UNITED STATES PATENT AND TRADEMARK OFFICE

APPLICATION NO.	FILING DATE	FIRST NAMED INVENTOR	ATTORNEY DOCKET NO.	CONFIRMATION NO.
10/542,011	07/12/2005	Hisamitsu Ishihara	113197-045	8933
24573 7590 06/19/2007 BELL, BOYD & LLOYD, LLP P.O. Box 1135 CHICAGO, IL 60690				
			EXAMINER CHOI, STEPHEN	
			ART UNIT 3724	PAPER NUMBER
			MAIL DATE 06/19/2007	DELIVERY MODE PAPER

DETAILED ACTION

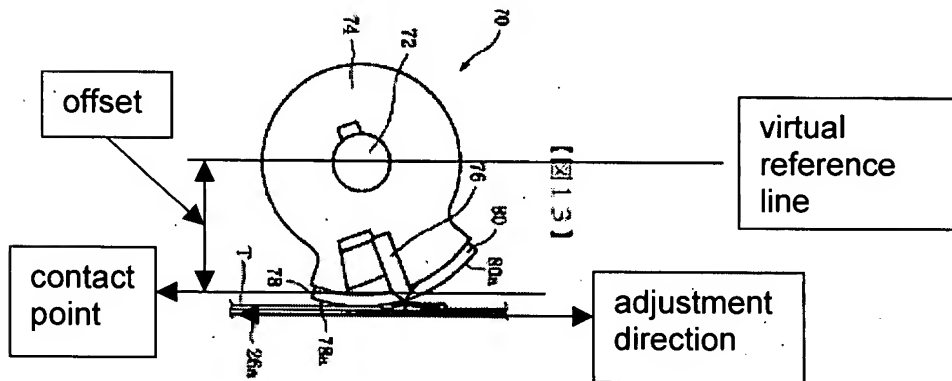
The examiner respectfully disagrees. '991 teaches an adjusting screw (e.g., 98) moving back and forward to adjust a location in the moving direction of the workpiece and a contact point between a blade edge of 114 and a blade edge of 76 is disposed at

an offset position deviated behind a rotational direction of the second cutter with respect to a virtual reference line that is parallel with the adjusting direction of the first cutter (see Figure below).
